INSPECTION REPORT
Sedimentation Structure
J3-A
Black Mesa Mine
Navajo County, Arizona
for
PEABODY COAL COMPANY

Dames & Moore
10139-011-22

Structure J3-A was inspected on September 4, 1985 by an interdisciplinary team of engineers from Dames & Moore. The purpose of the inspection was to assess the safety and general condition of the structure with respect to United States Department of Interior, Office of Surface Mining (OSM) regulations.

J-3A HYDRAULICS FOR REDESIGNED SPILLWAY

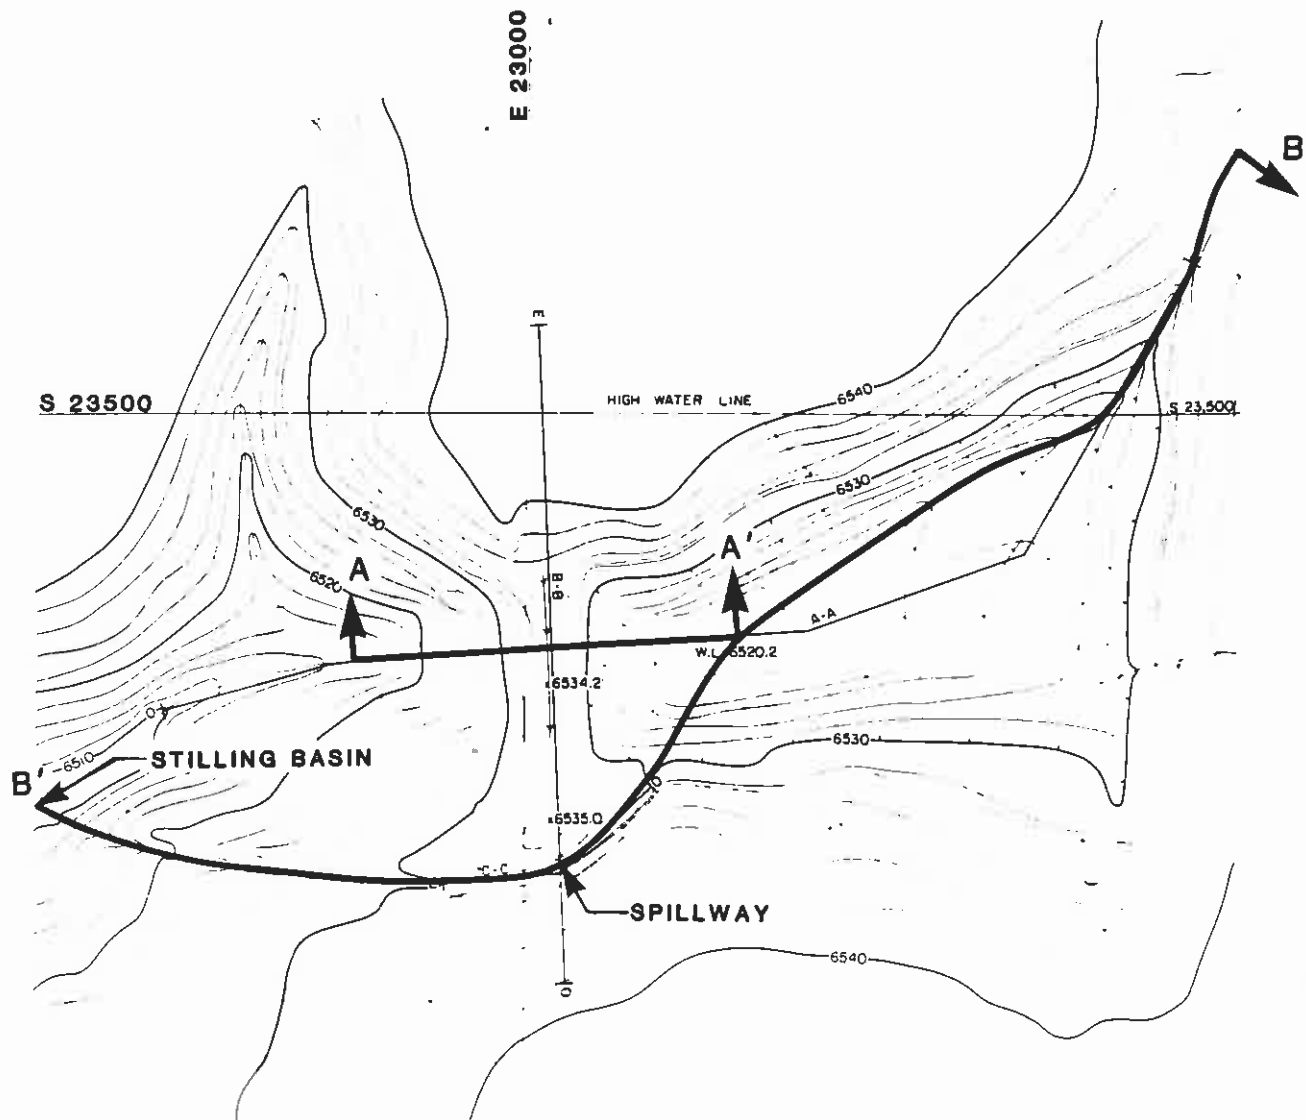
Lowering the spillway elevation to 6531.27 feet decreases the storage capacity and increases the freeboard. The analysis of these conditions is summarized in the following table.

10-year 24-hour Storm	25-year 6-hour Storm
Units			
<hr/>			
Initial Reservoir Volume			
Condition		Empty	Full to the spillway elevation
Inflow			
Peak Flow	cfs	86	103
Volume	acre-ft	4.59	3.93
Storage			
Peak Stage	ft	6529.74	6532.68
Spillway Elevation . .	ft	6531.27	6531.27
Peak Storage	acre-ft	4.59	--
Storage Capacity . . .	acre-ft	6.14	--
Available Sediment			
Storage Capacity . .	acre-ft	1.55	--
Sediment Inflow Rate .	acre-ft/yr	0.0555	--
Sediment Storage Life.	yrs	28	--
Outflow			
Peak Flow	cfs	--	44
Embankment Crest			
Elevation	ft	--	6533.84
Peak Stage	ft	--	6532.68
Freeboard	ft	--	1.16
Spillway Channel			
Flow Depth	ft	--	1.41
Critical Velocity. . .	fps	--	4.2
Manning's "n"		--	0.040
Outflow Channel			
			Section I Section II
Slope	%	--	6 16
Normal Velocity. . . .	fps	--	5.4 7.3
Normal Depth	ft	--	0.50 0.37
Manning's "n"		--	0.040 0.040

EXISTING
MAXIMUM CROSS-SECTION
A-A'
J3-A

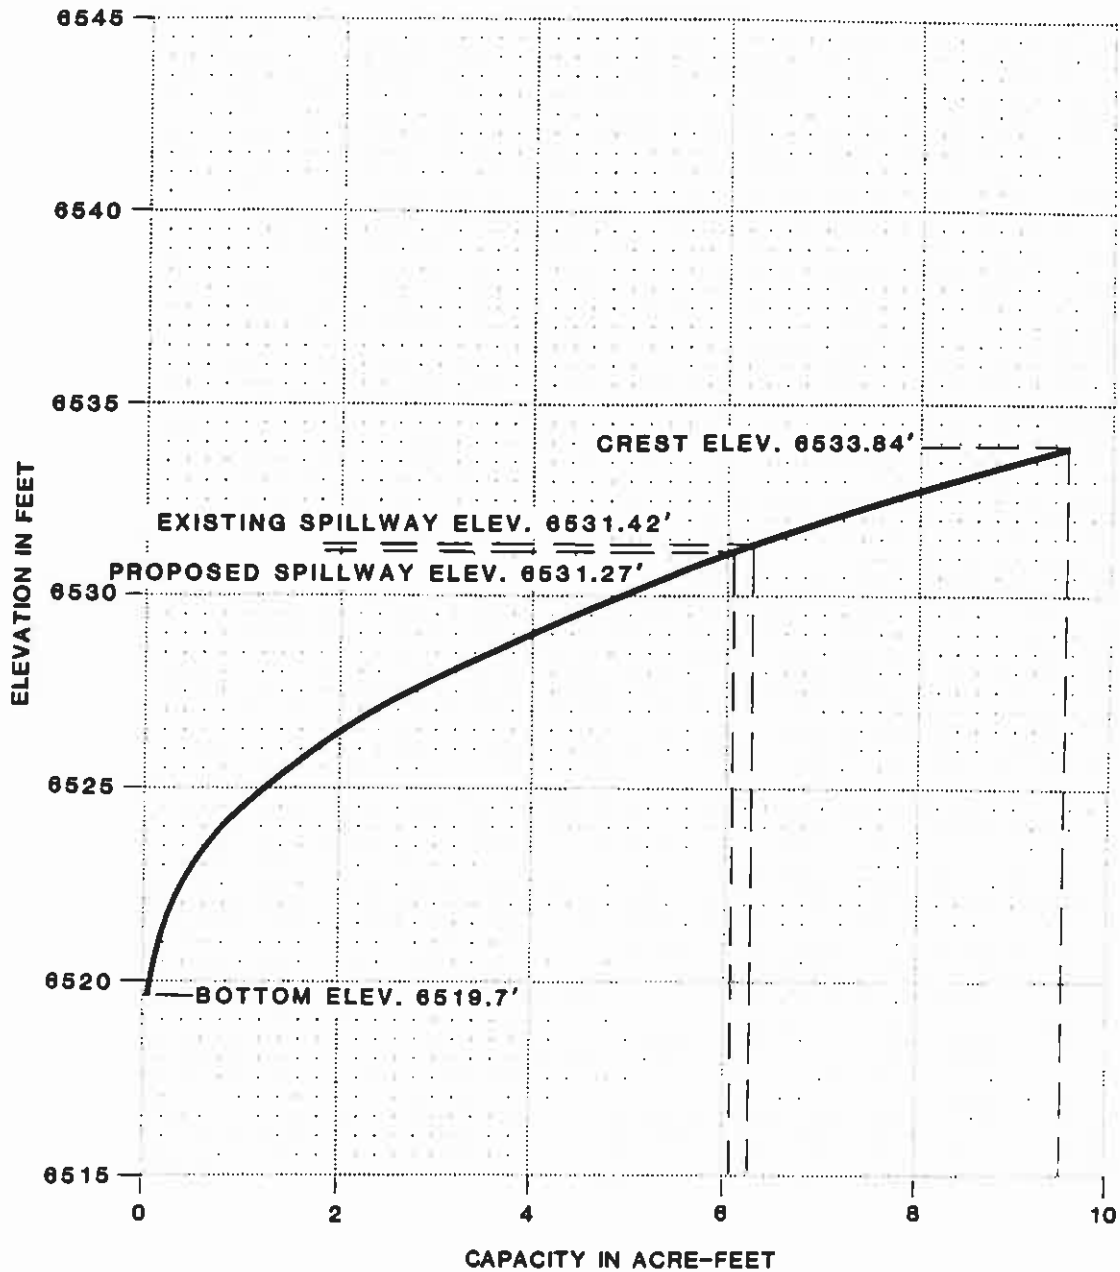
A cross-section of the embankment is shown on Plate 2, Existing Maximum Cross Section J3-A, A-A'. Grass provides erosion protection on the upstream and downstream slopes of the embankment.

SPILLWAY AND
OUTFLOW CHANNEL
CROSS SECTION
J3-A

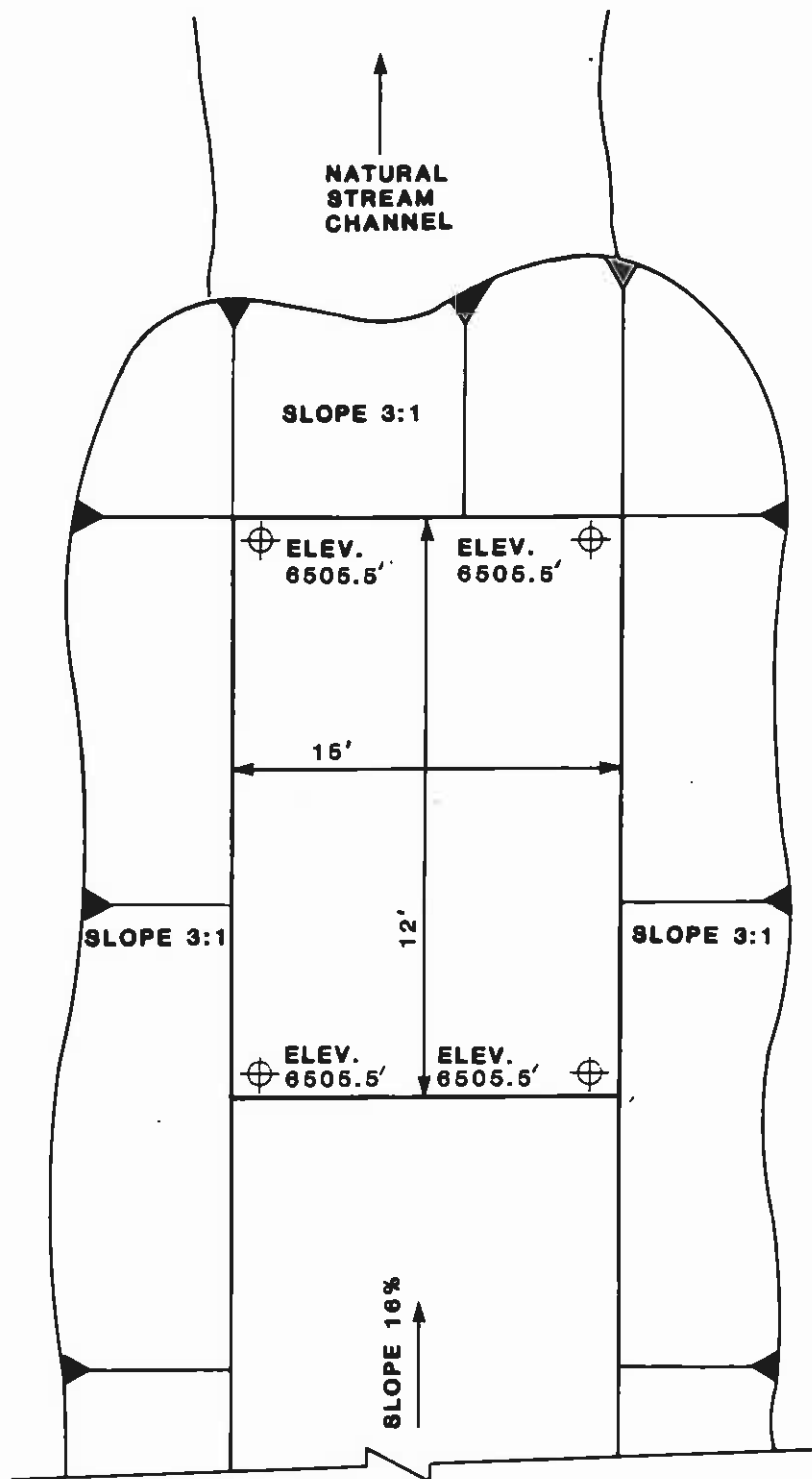
The storage capacity of Structure J-3A is adequate but the spillway capacity is inadequate. The structure does not have an adequate outflow channel. The bottom elevation of the existing spillway channel should be lowered to elevation 6531.27 while maintaining the bottom width of 15 feet as shown on Plate 5. A trapezoidal outflow channel with the same bottom width as the spillway and a stilling basin should be constructed along the alignment shown in Plate 1. The channel and stilling basin profile is shown in Plate 4 and required dimensions are shown in Plate 5 and Plate 6. The spillway, outflow channel and stilling basin should be protected against erosion using geotextile and riprap as shown in Plate 5.

$D = 2.5'$

LENGTH = 40'

FLOWLINE ELEV. = 6531.27'

$D = 1.5'$
